## STP MSPI FAQ – Mixed Status Systems

## Millstone MSPI FAQs:

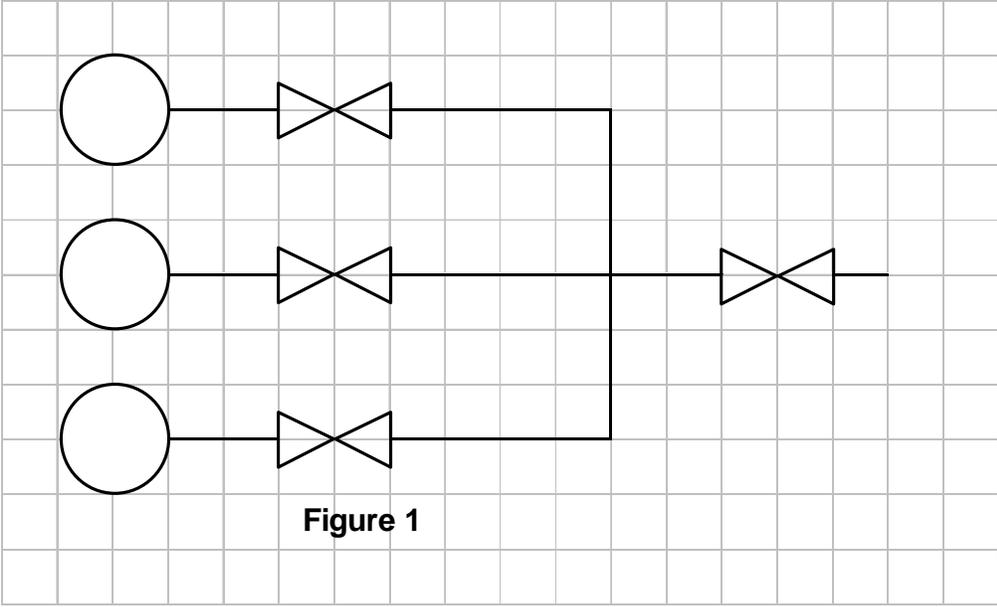
a) MP3 has three charging pumps. Each pump has one MOV on its recirculation line. There is an additional MOV on the common line (Figure 1). The three branch lines are power off one train and the common line is powered off the opposite train. Therefore for each pump either the common MOV or the branch line MOV must go closed. If the branch line MOVs and the common MOV do not close, all trains are lost. Would these valves be considered active?

**Proposed Response:**

The charging minimum recirculation valves would be counted as active valves since they do not meet the redundancy criteria in that a failure of all valves impacts both trains. The NRC staff concurs that this configuration is not a clear case of the straightforward parallel/series configuration discussed in Appendix F. However, it would appear that per the guideline in NEI 99-02, page 9, the fourth bullet, these valves need NOT be included as active components since no two combination of valve failures would fail all pumps.

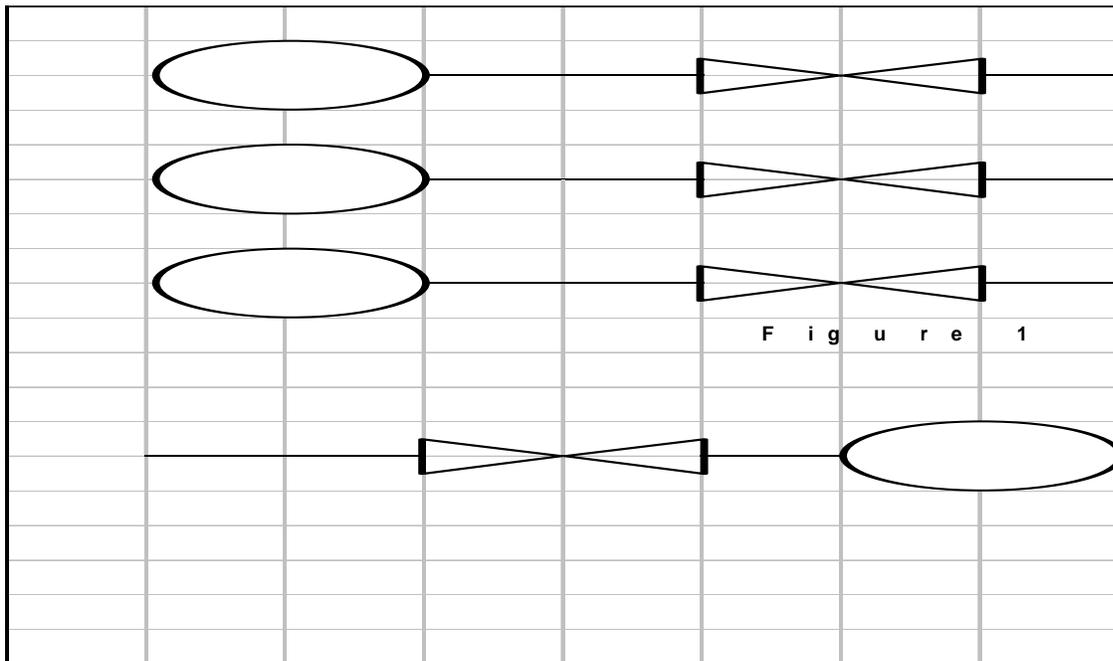
For recirculation MP3 has a two train system. Each train consists of two pump trains, of which one pumping train is required for recirculation (Figure 2). The pumping train consists of a suction MOV from the sump, a pump, and a discharge MOV to a common line which provides suction to either the intermediate head pumps or charging pumps. Each pumping train has its own discharge valves to the common header and can not be cross-connected. Since only one pumping train is required, are the suction and discharge valves considered active?

**Proposed Response:**

Yes since the pumping trains can not be cross tied. The success criteria and normal/accident valve positions must be better articulated. NEI 99-02, page F-9 should be reviewed to identify if any one valve in the train can fail the entire train. If not, then the valves need not be included as active valves.

Figure 3

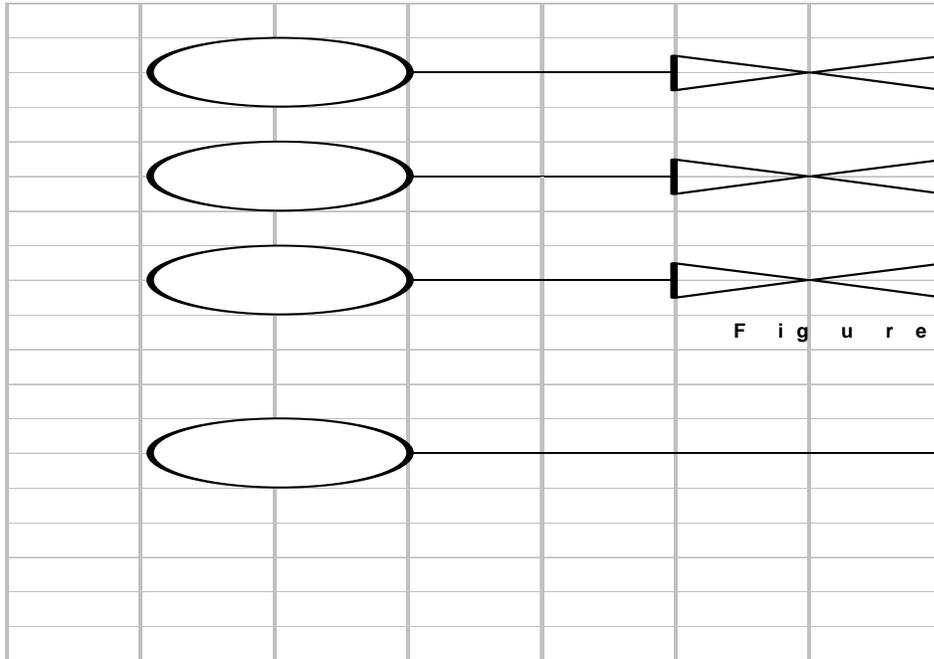
At MP3 there are two trains for hot leg injection. Each train has a MOV in its discharge line to the cold legs and there is also a MOV in the common line to the cold legs. During switchover to

hot leg injection, the discharge MOV to the cold legs is closed and the hot leg injection MOV is opened for one train and then the other train and then the common cold leg MOV is closed. To meet the hot leg injection requirements either the two discharge MOVs or the common cold leg MOV need to be closed. Would these valves be considered active?

**Proposed Response:**

Yes since if both the discharge MOVs or the common line MOV did not close both trains of hot leg injection would be lost. The success criteria as well as normal/accident valve positions for both the cold leg injection and the hot leg injection functions must be better articulated. NEI 99-02, page F-9 should be reviewed to identify if any two valve failures can fail the entire system function. If not, then the valves need not be included as active valves.
